C.N. Lalla Esqr;
Architect; Karachi.Re: plot No. 129, 130, K-8 Lyari Cr.

REFERENCE No. L. M. A. B. S. P. B. 272 OF 1929

With reference to your application dated 9.7.29, 19 ,
with a plan for the proposed building/additions and alterations on plot
No. 129, 130, Survey Shee No. 148, 149, 150 quarter
I have the honour to inform you that until the following requirements
are complied with plans cannot be passed:—

PLAN OF PROPOSED ADDITIONS & ALTERATIONS ON PLOT NO 129 & 130 SHEET NO K-8

ROAD
GROUND PLAN

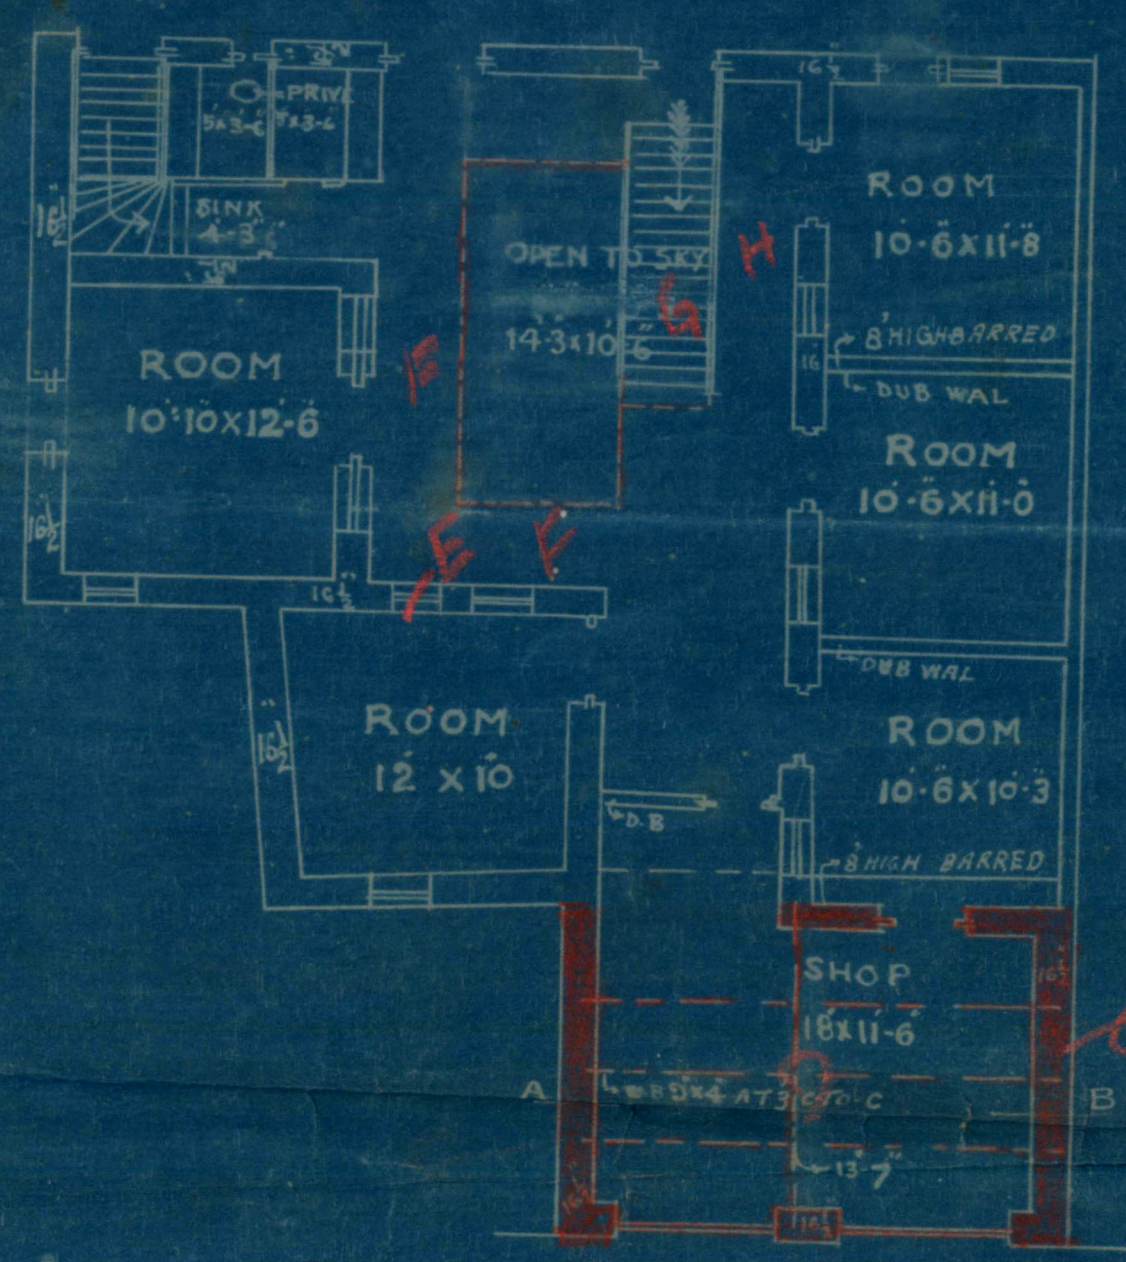
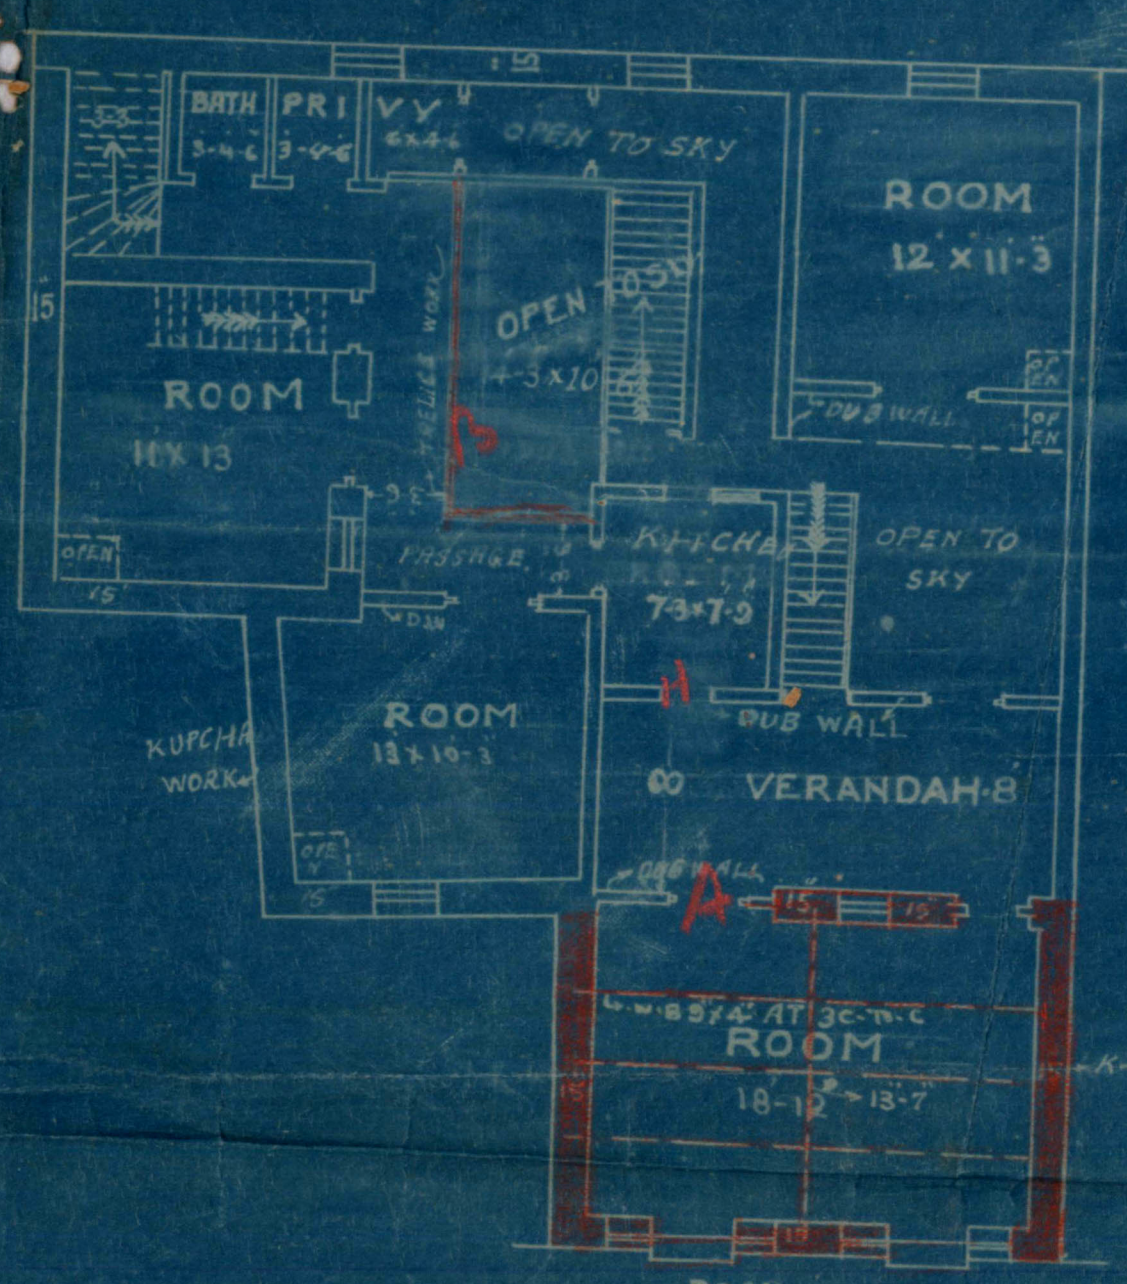
- (1) Proposed additions will render the existing building dark
 - (2) Section line A B be given
 - (3) How date wall is going to rest.
 - (4) How passage B is going to be supported.
 - (5) wall C must be newly constructed & shown red
 - (6) Existing wall D to be removed and a level provided.
 - (7) window E does not exist & should be marked red
 - (8) Passage F should be dimensioned as 4'
 - (9) Stair case G should be shifted to position H to increase central open space
 - (10) All the existing walls require painting & latching
 - (9) Gunner is advised to remove the existing structure & renew it as money spent on the
- The plans are returned herewith for amendment.
proposed work is not justifiable.

1) H.O's objection.

3) Front pillars be of annular masonry as the opening
more than half.

4) How door wall is going to be.

5) How passage B is going to be supported.

6) wall E should be newly constructed & secured.

7) Existing wall D to be removed and a line to be
provided, none of which should be specified.

8) window (E) does not exist & should be marked Red for

9) passage F should be dimensioned 6' 6" as it being proposed

10) Stair case G should be shifted to position H to increase
central open space.

- (1) As required by health officer, I have opened roof of one room and made grated and also increased open area at the back.
- (2) Section line is ~~max~~ shown.
- (3) Sub walls will rest ^{on beams} and sizes of those beams are shown on plan.
- (4) Passage is to rest on posts which are shown.
- (5) Existing wall & D is removed and lintels provided.
- (6) proposed wall is shown in red.
- (7) window is shown in red.
- (8) passage is made 4'
- (9) staircase is shifted as desired by you.
- (10) all walls shall be cement painted as desired by you. The building is new but being not occupied appears dirty.

SECTION ON A-B

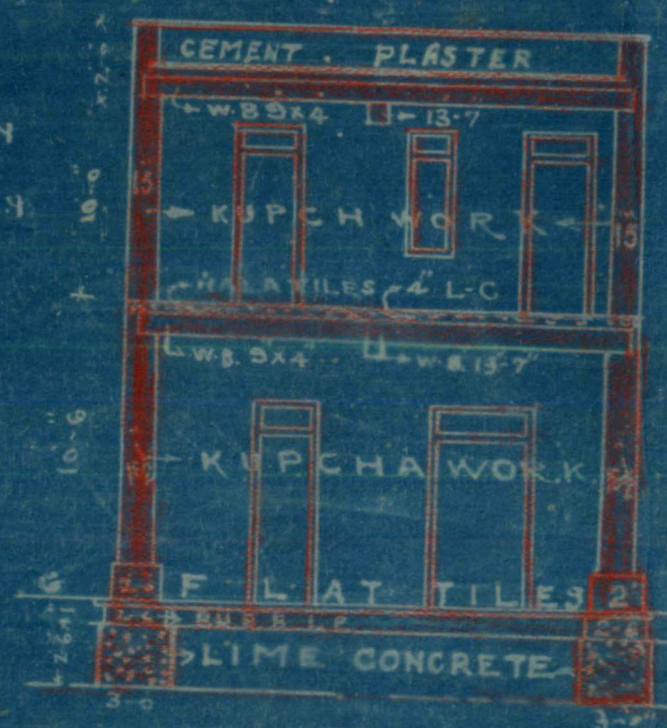
2) Section line A B be given.
